Proposal for new supplement to the 07 series of amendments to UN Regulation No. 49

Submitted by the experts from France.

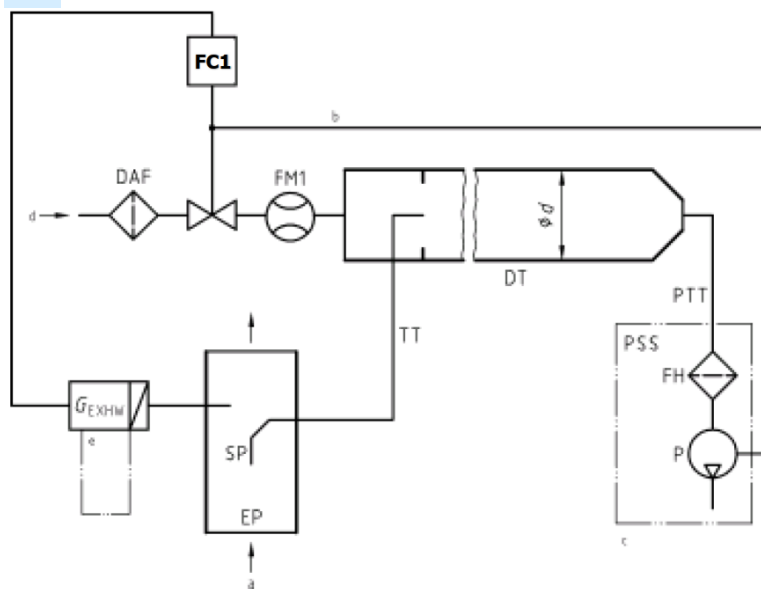
$$Re = A_1 \times 60 \times \frac{Q_{SSV}}{d_v \times \mu} \quad (90)$$

A_1 is ~~25.55152~~ **27.43831** in SI units of $\left(\frac{kg}{m^3}\right)\left(\frac{min}{s}\right)\left(\frac{mm}{m}\right)$

a = exhaust b = optional c = details see Figure 16
 ..."
